RS-02-021

Subject: Response to Request for Additional Information Regarding a Previous License Amendment Request to Revise the Fuel Centerline Temperature Safety Limit for Byron and Braidwood Stations

Response to Request for Additional Information

Figure 1
Cladding Corrosion Thickness vs. Fuel Duty Index

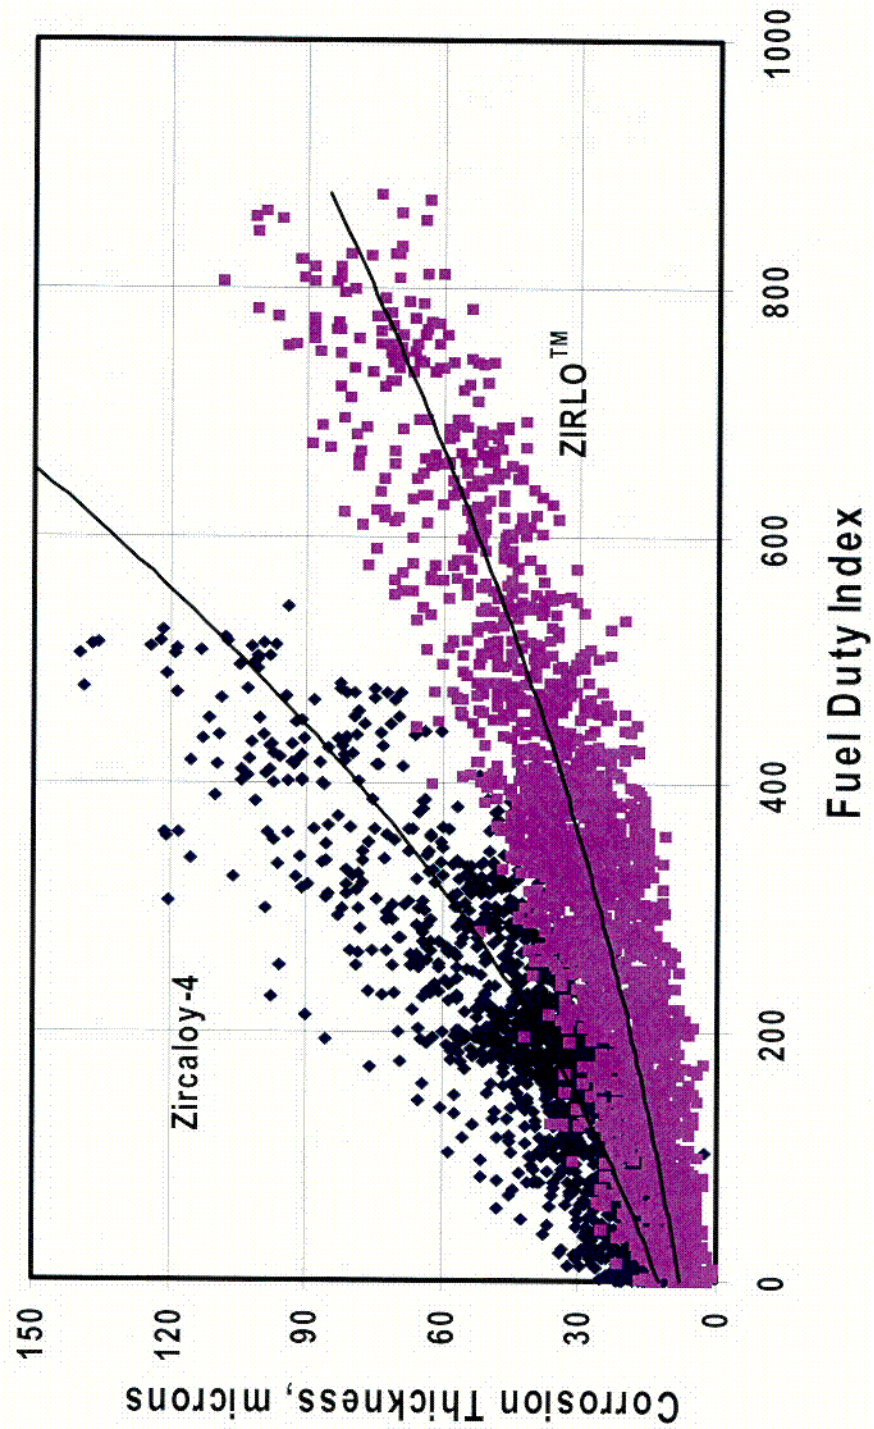
Describe the fuel duty that the four higher burnup rods have seen thus far. What type of duty will these rods see during the next cycle?

The Fuel Duty Index (FDI) for the lead burnup rod (i.e., E4) after the second cycle was 331. The projected FDI after completion of the third cycle is 634. A plot of Cladding Corrosion Thickness vs. Fuel Duty Index for Zircaloy-4 and ZIRLO fuel is provided in Figure 1.

FIGURE 2-1
BYRON UNIT 2 CYCLE 10
REFERENCE CORE LOADING PATTERN

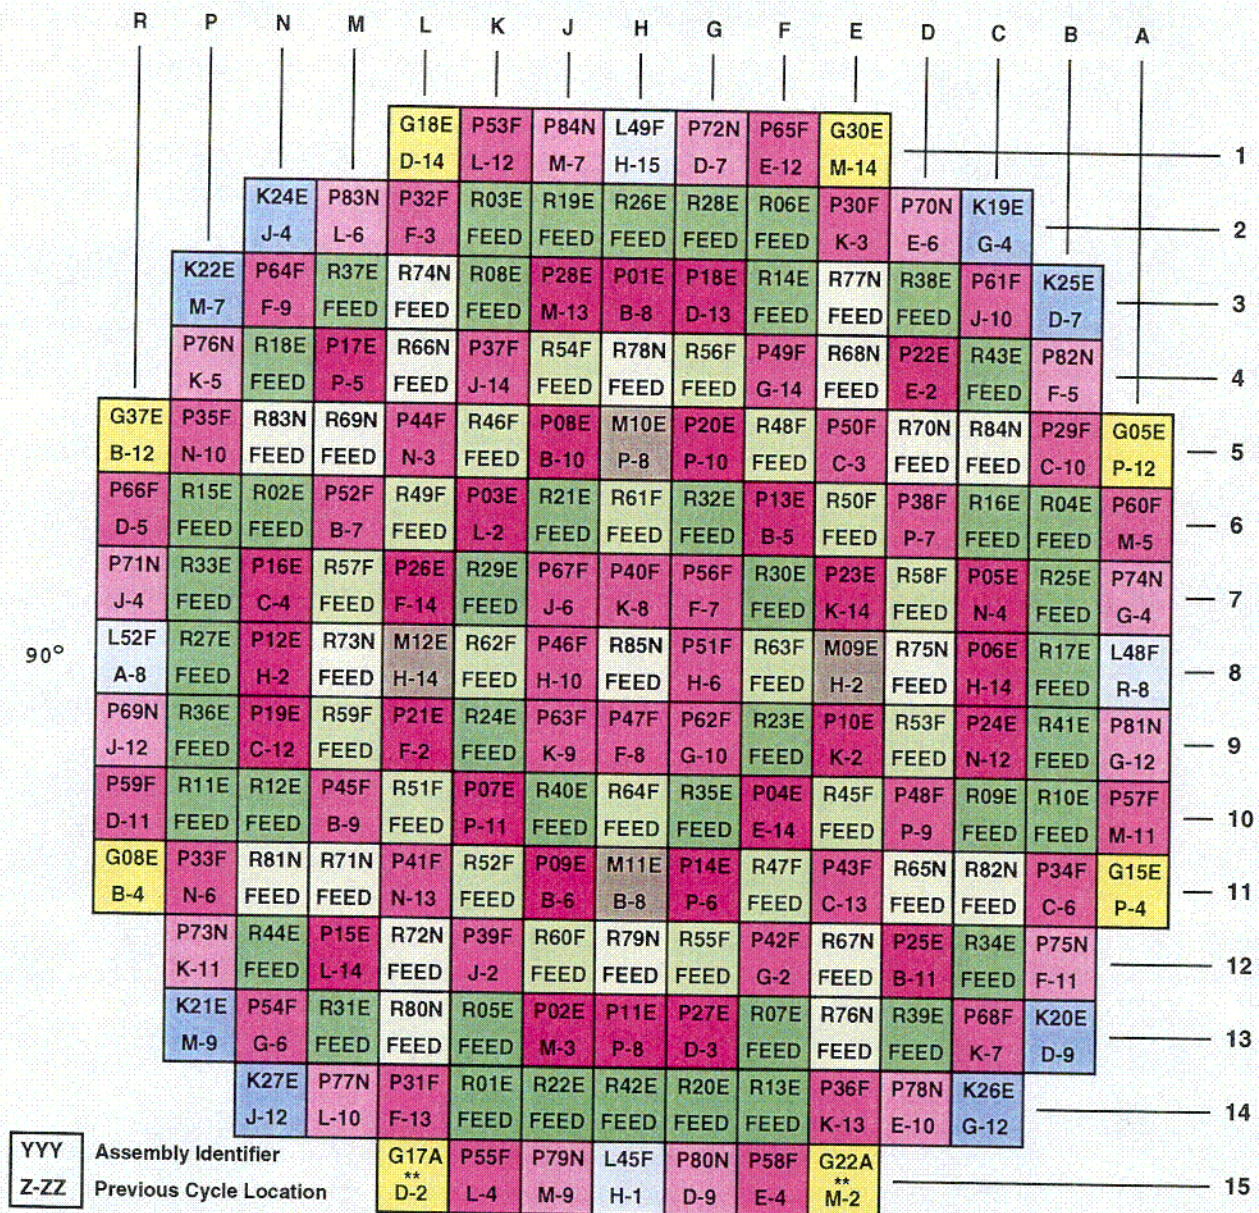
Where is LTA M09E located in the core and is it in a "near limiting" core location?

LTA M09E is located in core location E8. Figure 2-1 provides a reactor core map indicating the location of LTA M09E. Figures 3a, 3b, 3c, and 3d provide quarter core calculated assembly power and Enthalpy Rise Hot Channel Factor ($F^N\Delta H$) values for cycle burnups of 0 MWD/MTU,

4000 MWD/MTU, 12000 MWD/MTU, and 22000 MWD/MTU. These figures indicate that LTA M09E is not in a "near limiting" core location; however, the LTA is not on the core periphery and is experiencing approximately an average core power and $F_N\Delta H$. Note that there is a second LTA (i.e., LTA M12E) located in symmetric core location L8; however, this LTA does not contain any high burnup rods.
